UNITED STATES PATENT AND TRADEMARK OFFICE

APPLICATION NO.	FILING DATE	FIRST NAMED INVENTOR	ATTORNEY DOCKET NO.	CONFIRMATION NO.
10/764,908	01/26/2004	Fang Lei	02581- P0553A	3365
24126	7590	10/03/2005	EXAMINER	
ST. ONGE STEWARD JOHNSTON & REENS, LLC 986 BEDFORD STREET STAMFORD, CT 06905-5619			NGUYEN, THONG Q	
			ART UNIT	PAPER NUMBER
			2872

Office Action Summary

DETAILED ACTION

FIG.1

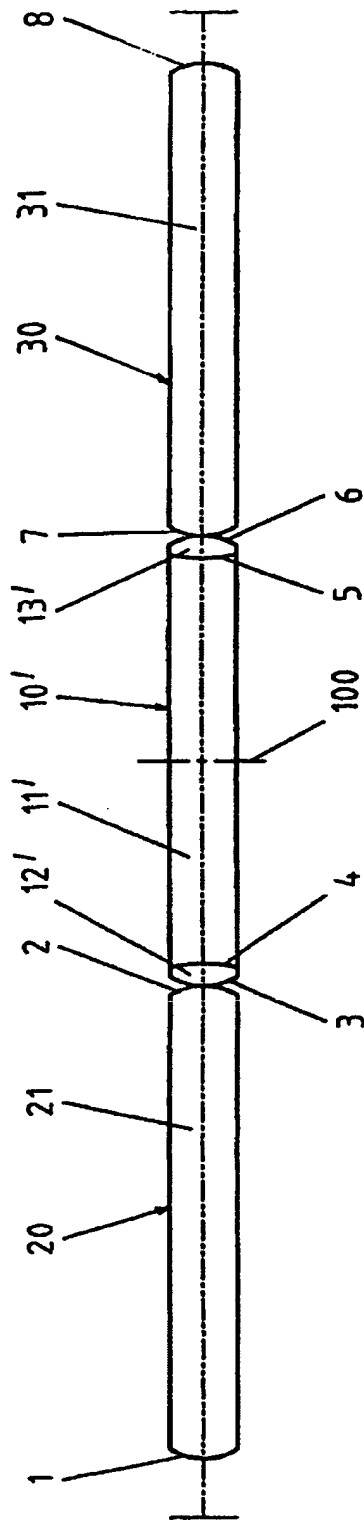
3. The drawings contained seven sheets of figures 1-7 were received on 7/18/05. These drawings except figure 1 are approved by the Examiner.

4. The drawings are objected to as failing to comply with 37 CFR 1.84(p)(5) because they include the following reference character(s) not mentioned in the

description: The numerical references "21" and "31" shown in figure 1 are not mentioned in the specification. Corrected drawing sheets in compliance with 37 CFR 1.121(d), or amendment to the specification to add the reference character(s) in the description in compliance with 37 CFR 1.121(b) are required in reply to the Office action to avoid abandonment of the application. Any amended replacement drawing sheet should include all of the figures appearing on the immediate prior version of the sheet, even if only one figure is being amended. Each drawing sheet submitted after the filing date of an application must be labeled in the top margin as either "Replacement Sheet" or "New Sheet" pursuant to 37 CFR 1.121(d). If the changes are not accepted by the examiner, the applicant will be notified and informed of any required corrective action in the next Office action. The objection to the drawings will not be held in abeyance.

It is noted that in the amendment, page 14, the second paragraph, applicant has stated that the references "21" and "31" have been removed; however, such references are still shown in figure 1 of the corrected drawings filed on 7/18/05.
